## Procedure to add In-line Fuse

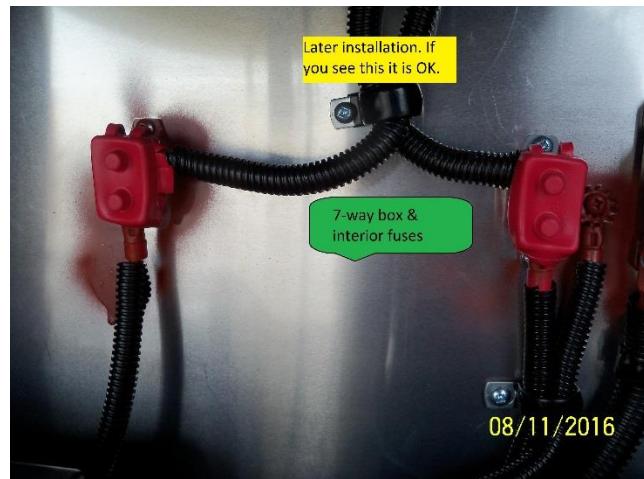
- 1) Locate positive (+) wire at trailer battery. This would be a red #8 wire that feeds the 12 V Junction Box at the front of the trailer under the Goose Neck Coupler. The 7-way trailer/truck lead connects to this as well.

- 2) Turn courtesy light "on" by the junction box. Loosen the nut that holds the red #8 wire to + terminal at battery. To verify that you have the correct wire the light will no longer work.

- 3) Bring the end of this wire away from battery, cut off ring terminal. Strip end of this wire ½". Attach this end to stripped end of the in-line fuse (provided) with the sealed twist cap connector (provided).

- 4) Attach other end of in-line fuse (with ring terminal) to the + battery post, and the courtesy light should work again.
- 5) Reinstall battery cover, straps to original position.

- #1 Locate positive (+) wire
- #2 Loosen Nut
- #3 bring wire away from battery, cut off ring terminal, strip end 1/2", attach this to stripped end of in-line fuse wire with connector provided
- #4 attach ring terminal end to battery + post.

- Junction box as described in #1
- Courtesy light as described in #2 as well as #4

- Parts that are supplied;
- 30 amp in-line fuse link
- Sealed wire cap
- Order Kit #82316**
